Access Compliance Report

Public Rights-of-Way

(Curb Ramps)

Intersection ID: 23437	Main Street: TRYON_ST	Cross Street: MOSS_LN	Location: W
ADA ID: F0D56C621614	Ramp Type: MedianPerp	Initial Pass/Fail: Fail	Overall Compliance: No
Severity Score: 12.5			
Codes/Mitigation Info/Possible Solution		Field Measurements/Component Compliance

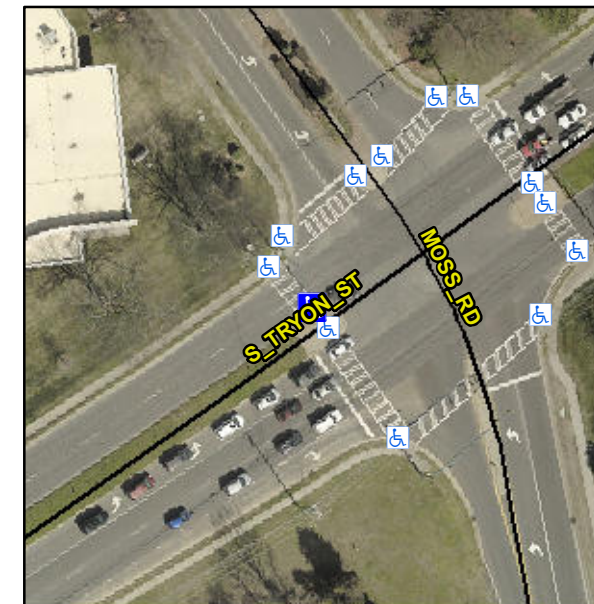
Not Found, R304.2.2

Compliance	Description	Data	Compliance	Description	Data
N/A	Ramp Length (in)	72.0	No	Ramp Slope (%)	9.0
Yes	Ramp Width (in)	48.0	Yes	Ramp XSlope (%)	1.1
N/A	Flare Type LT	N/A	N/A	Flare Type RT	N/A
N/A	Flare Slope LT (%)	N/A	N/A	Flare Slope RT (%)	N/A
N/A	Flare Traversable LT?	N/A	N/A	Flare Traversable RT?	N/A
N/A	Landing Length (in)	N/A	N/A	DWS Provided?	N/A
N/A	Landing Width (in)	N/A	N/A	DWS Contrast?	N/A
N/A	Landing Slope (%)	N/A	N/A	DWS Length (in)	N/A
N/A	Landing X Slope (%)	N/A	N/A	DWS Full Width?	N/A
N/A	Landing Curb? (Y/N)	N/A	N/A	DWS Offset (in)	N/A
N/A	Shared Landing?	N/A			
N/A	Gutter Ponding?	N/A	N/A	Gutter Slope (%)	N/A
N/A	Gutter Lip Ht (in)	N/A	N/A	Gutter X Slope (%)	N/A
N/A	Painted X Walk1?	Yes	N/A	Painted X Walk2?	N/A
	X Walk 1 Direction	To N		X Walk 2 Direction	N/A
N/A	X Walk 1 Width (in)	118.0	N/A	X Walk 2 Width (in)	N/A
	X Walk 1 Slope (%)	1.3		X Walk 2 Slope (%)	N/A
	X Walk 1 X Slope (%)	1.4		X Walk 2 X Slope (%)	N/A

Remove & Replace Entire Ramp.
